Schematic	gat_holder_basic_single		Update Date	2024-11-06
Page	Page1		Create Date	2024-10-14
Drawn	true		Part Number	tC-SC8-02
Reviewed				
<b>The GAT Stand</b>				
	VER	SIZE	PAGE	1 OF 1
	REV4	Letter	schematics, instructions, firmware updates <a href="https://basic.truecontrol.org">https://basic.truecontrol.org</a>

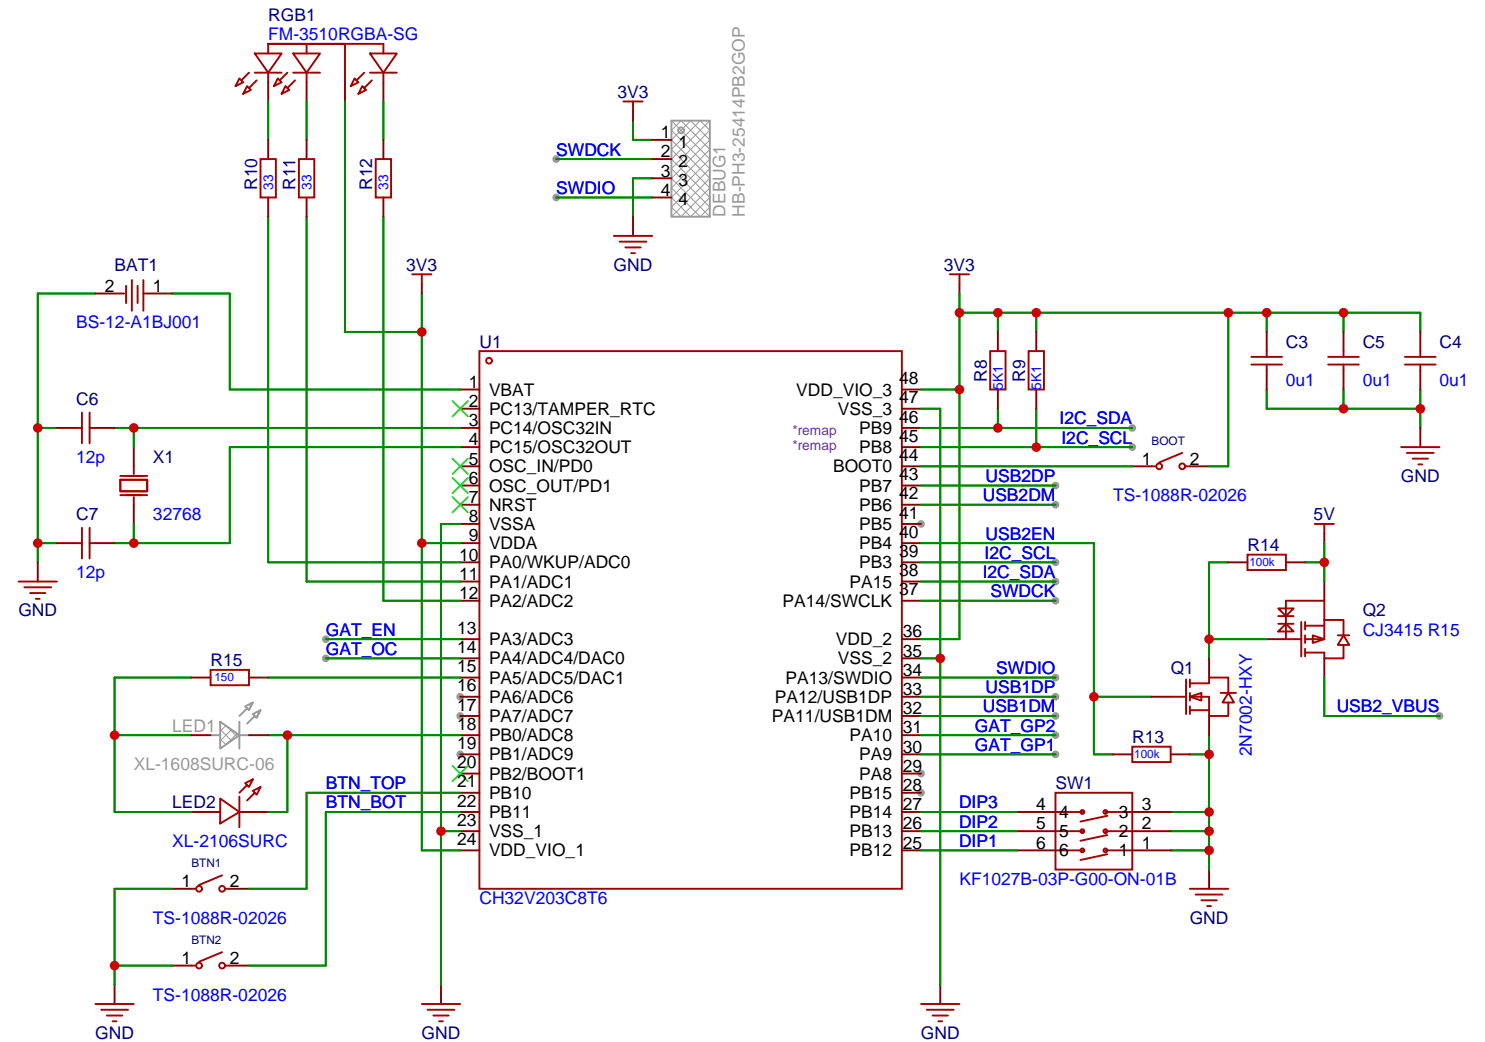
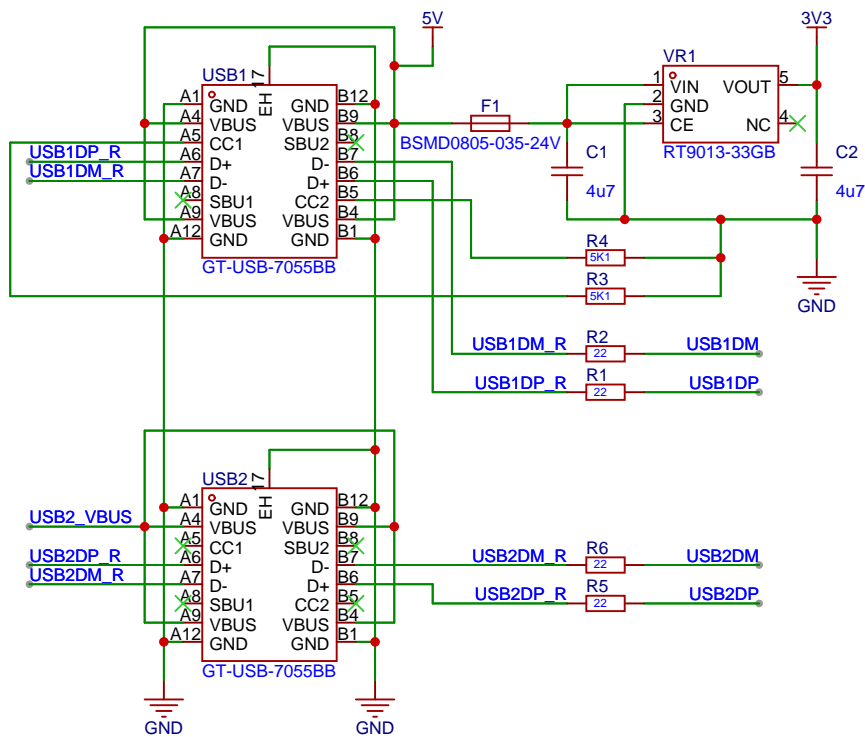
Known issues REV4:

- Fuse F1 should be between VR1-VOUT and U2-IN. Large currents on switched output can cause VR1 to undervolt, resetting the MCU. Moving this fuse would limit the undervolt and MCU would not reset. There isn't any high power 3V3 circuit to protect other than the addon connector.
- GAT\_OC can never trip, as either fuse or LDO overcurrent will happen first.
